EUROPEAN
COMMISSION

Commission implementing Regulation

**amending Commission Regulations: (EU) No 321/2013, No 1299/2014, No 1300/2014,
No 1301/2014, No 1302/2014, No 1304/2014 and Commission Implementing
Regulation (EU) 2019/777**

The Annex to Regulation (EU) No 1299/2014 is amended as follows:

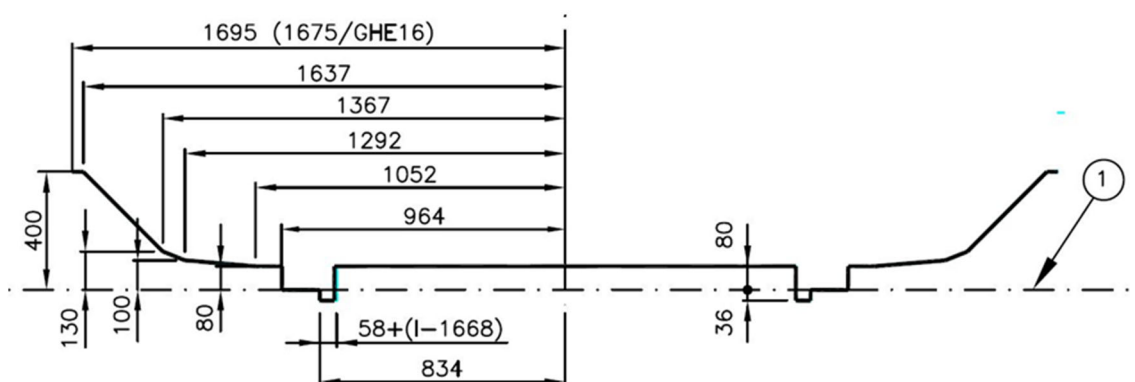
- (52) Appendix P is amended as follows:

- (a) the second paragraph is replaced by the following:

“Calculations of structure gauge shall be done using the kinematic method in accordance with the requirements of the specification referenced in Appendix T, Index [3] with the kinematic reference profiles and associated rules defined in this Appendix.”;

- (b) In point P.1.2, the figure 13 is replaced by the following ones:
